ADDENDUM NUMBER ONE
to the
PROJECT SPECIFICATIONS and CONTRACT DOCUMENTS
for the
Smoke Tree Lane Water and Pavement Improvements Project

DATE OF ADDENDUM: April 4, 2016

WASTEWATER PLAN
GENERAL NOTES

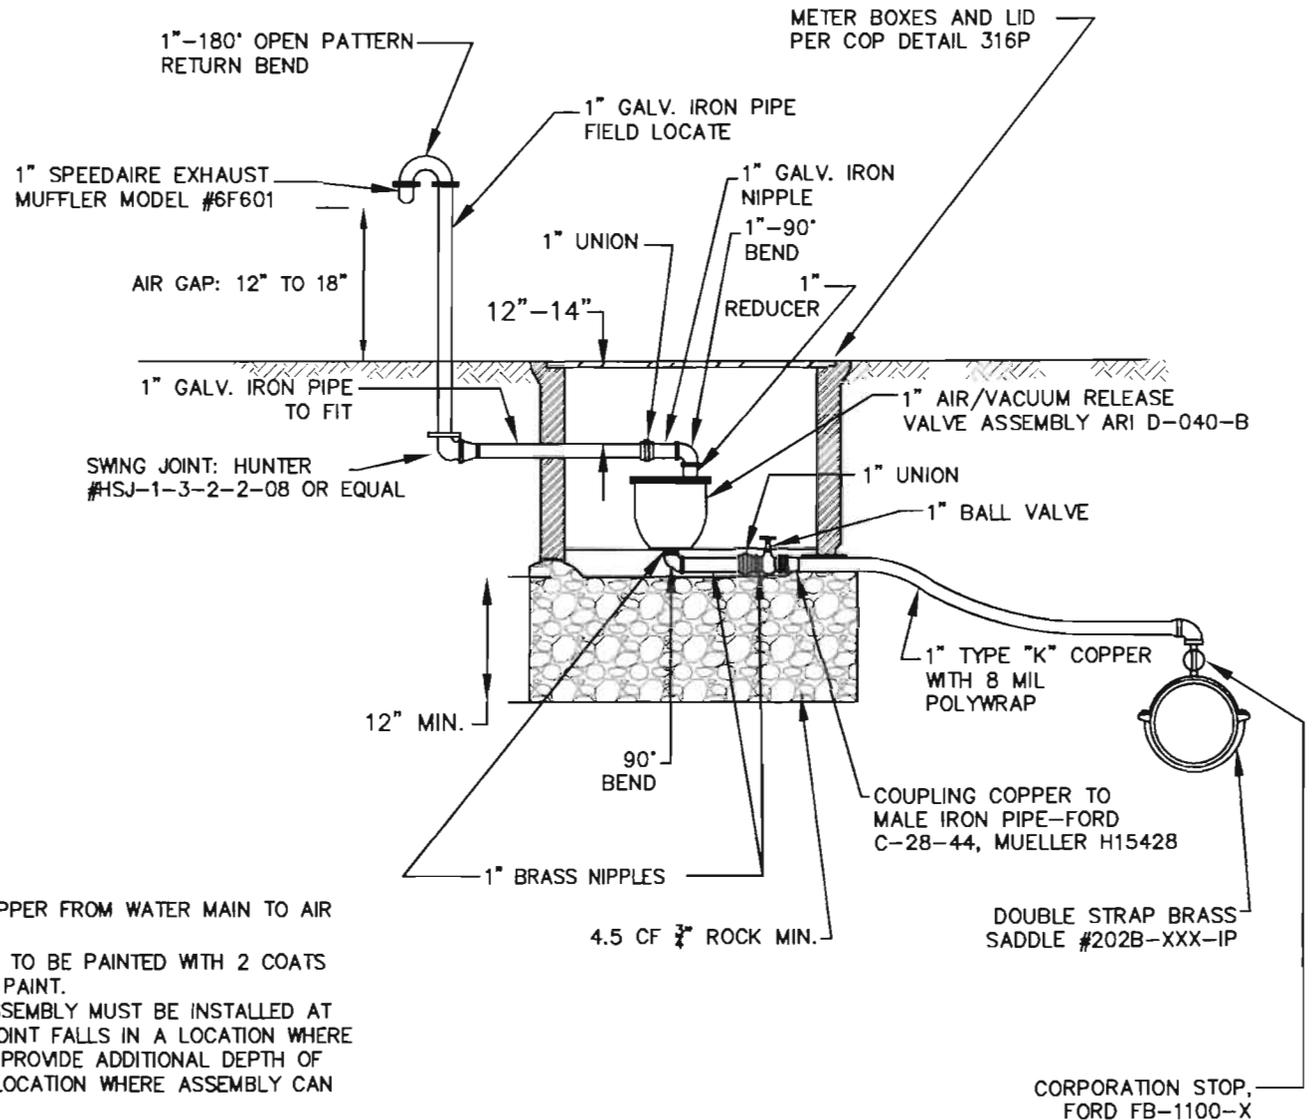
Change: The Sewer Plan General Notes on Plan Sheet TD1.4 shall be replaced by COP Standard Detail 104P attached hereto.

COP STANDARD DETAIL	1" AIR VACUUM RELEASE VALVE ASSEMBLY	CITY ENGINEER	REVISED: 01/15	DETAIL No. 317P
---------------------	--------------------------------------	---------------	-------------------	--------------------

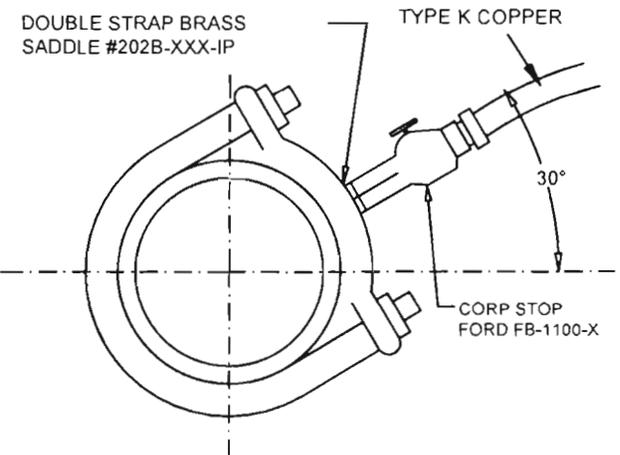
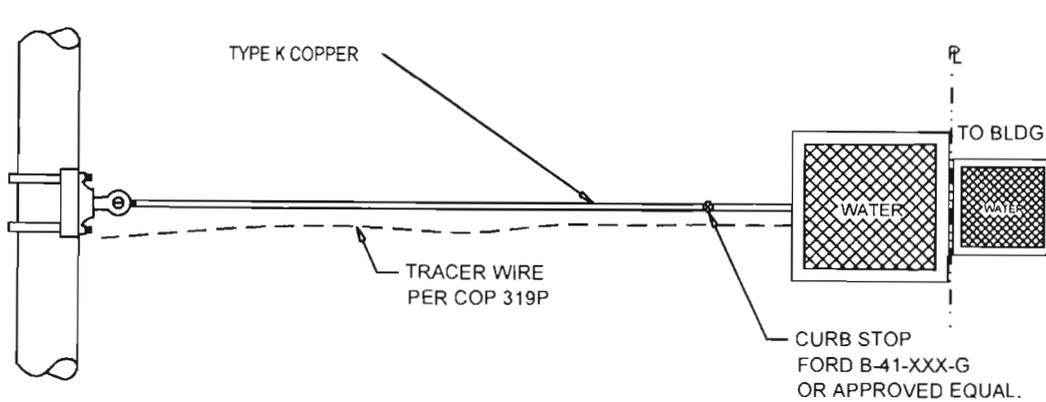
COP Standard Detail 3-17P on the Plans is replaced by COP Standard Detail 317P, attached hereto.

Clarification: Air Release Valves on the 18" water main shall be 2". Air Release Valves on the 8" water main shall be 1".

DETAIL No. 316P

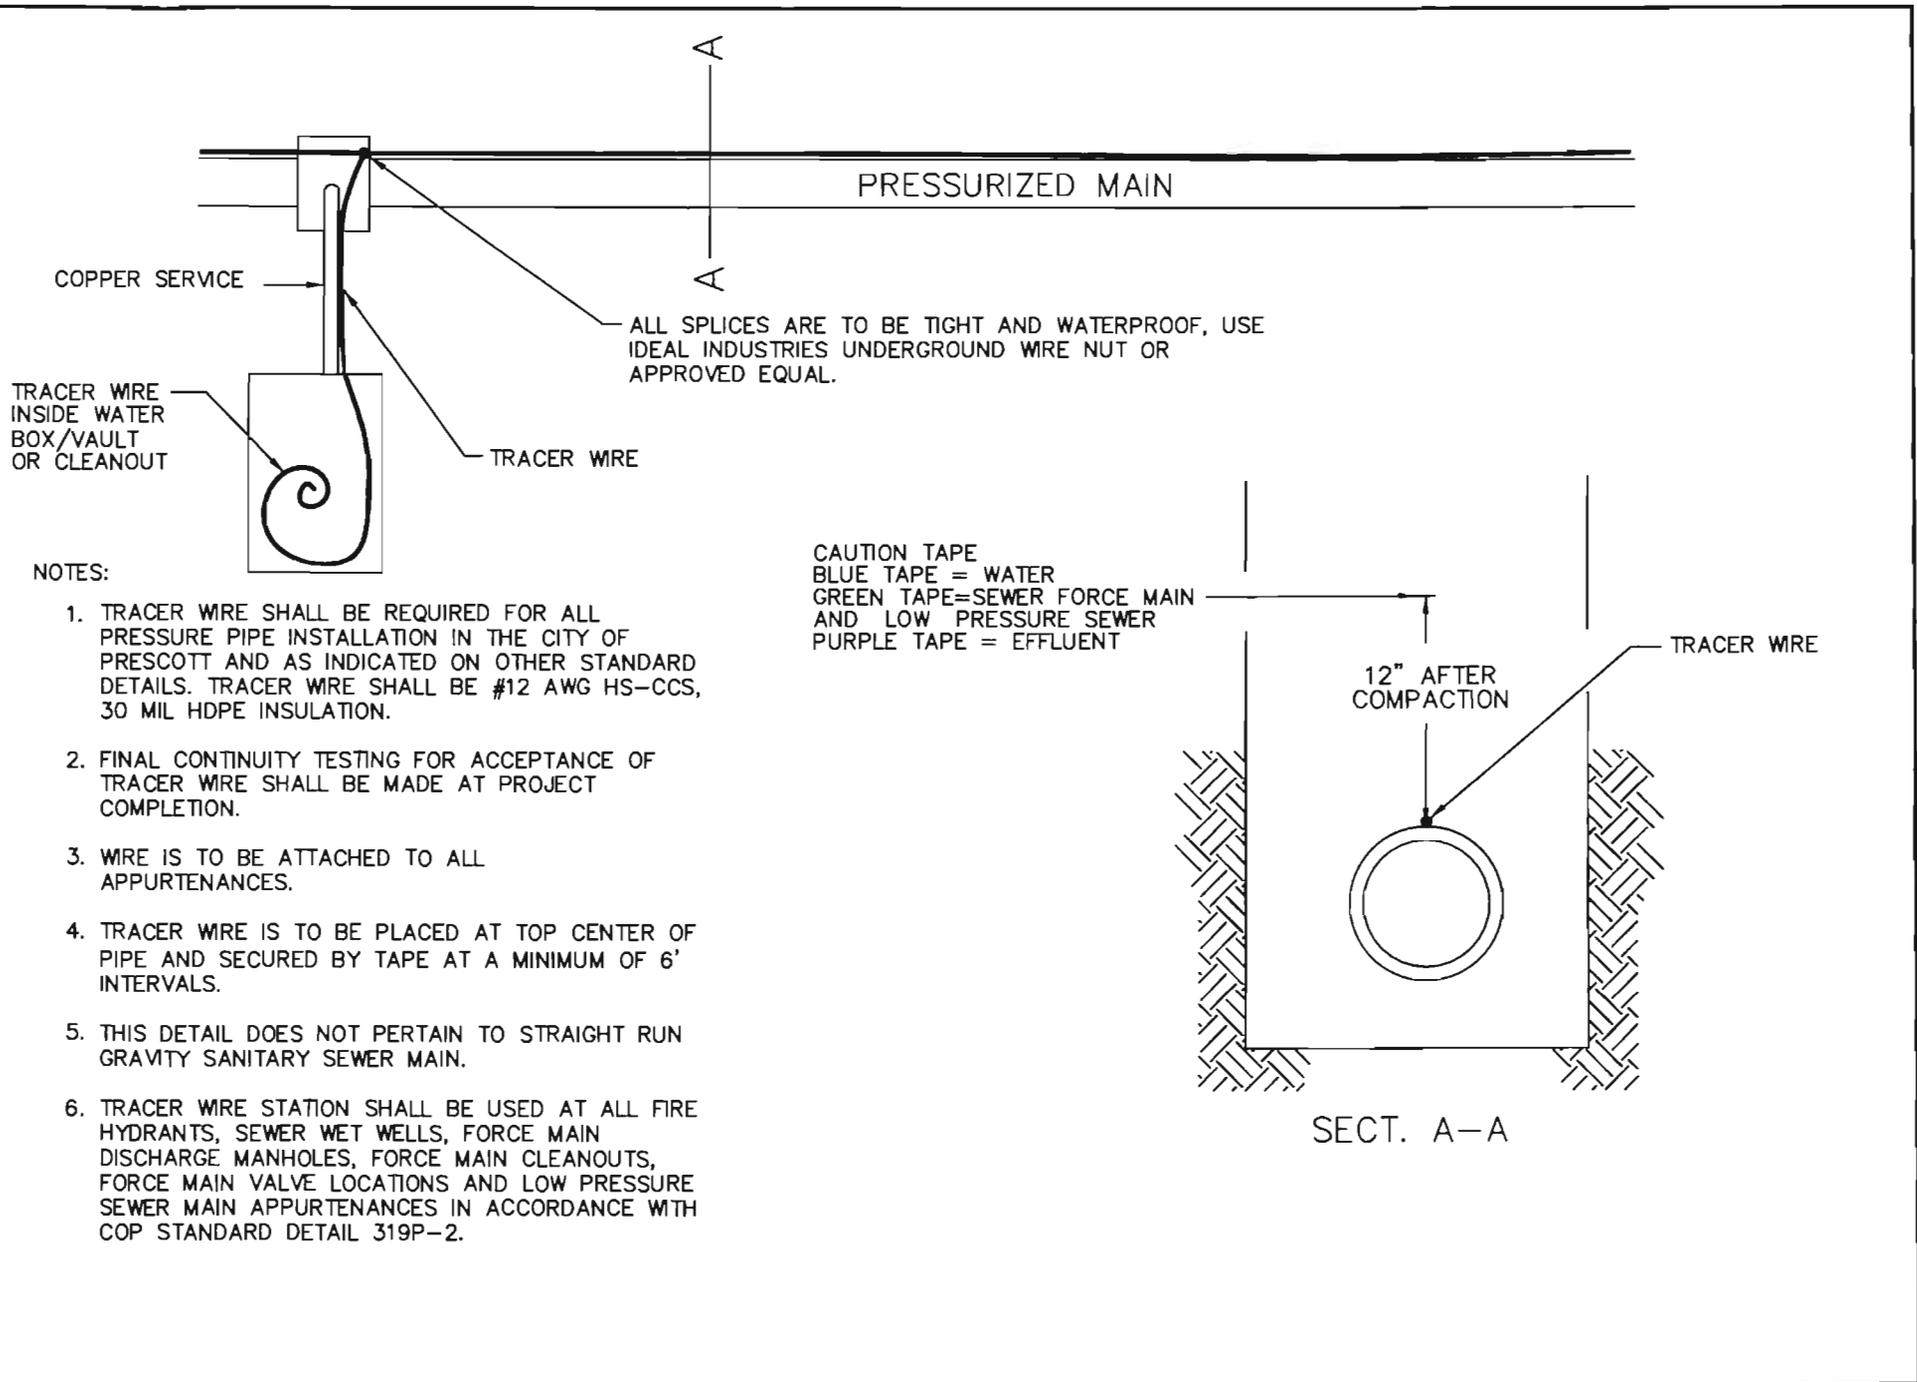
COP Standard Detail 3-16P on the Plans is replaced by COP Standard Detail 316P, attached hereto.

391P

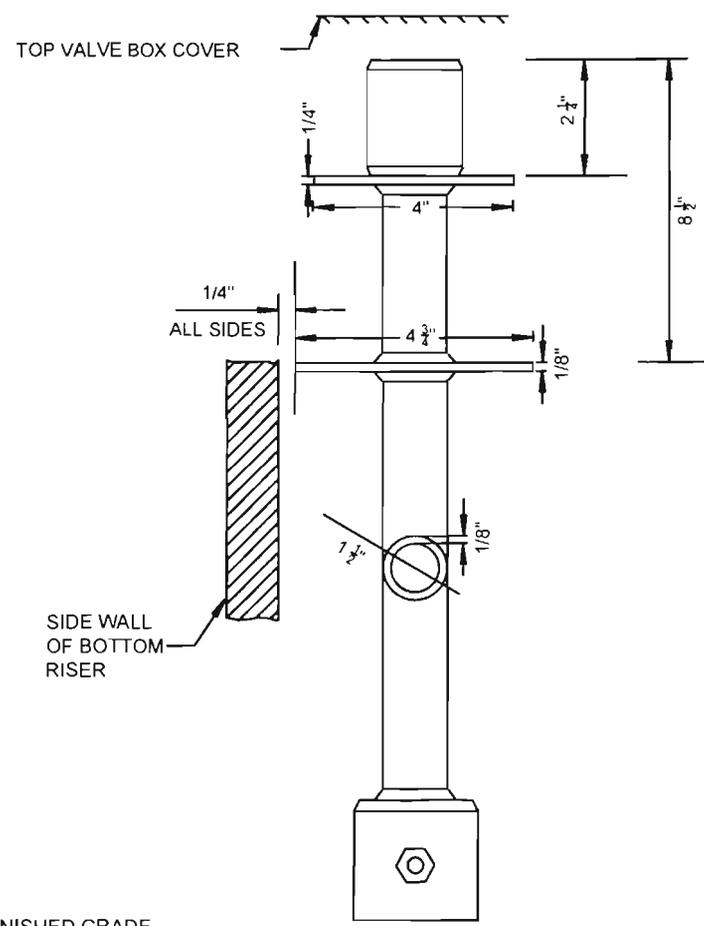
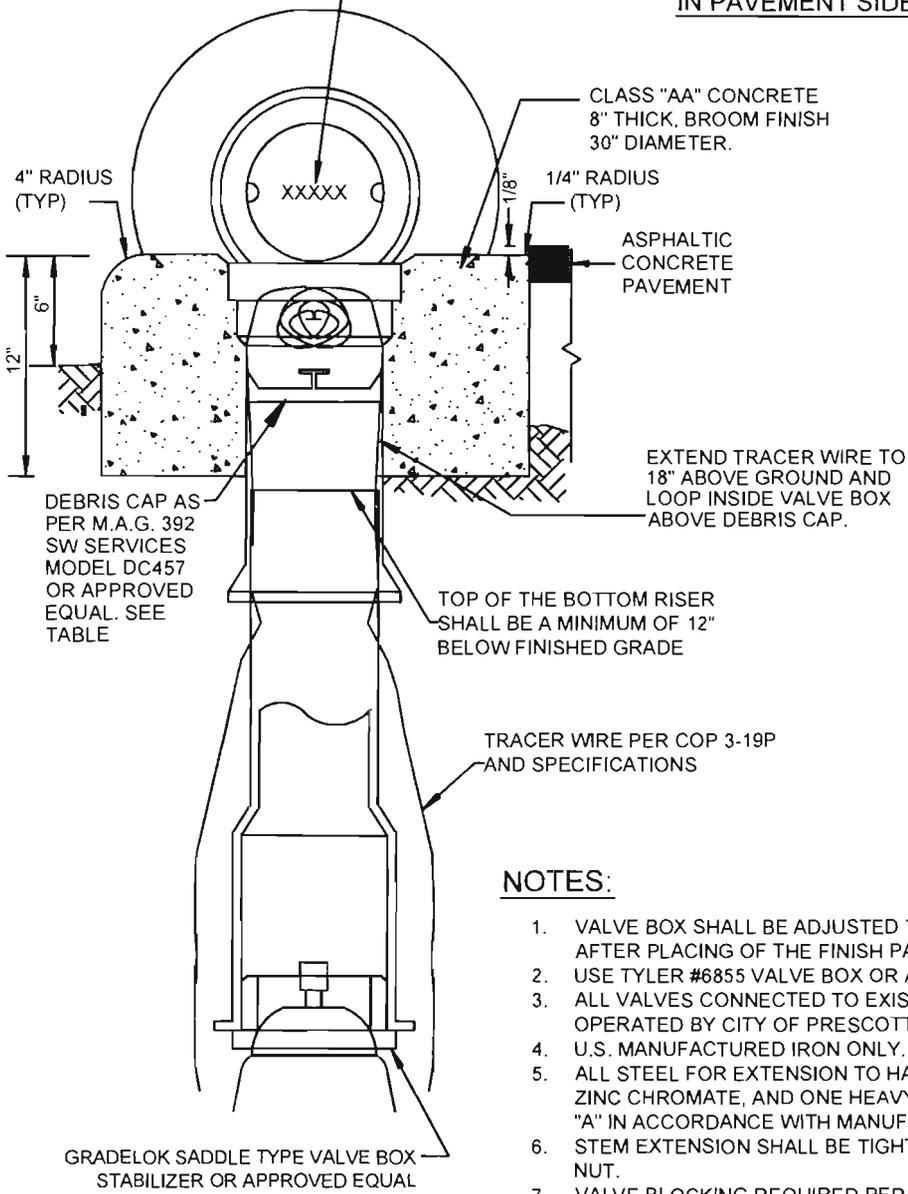
Clarification: COP Standard Detail 391P is attached hereto as referred to on COP Standard Detail 301P.
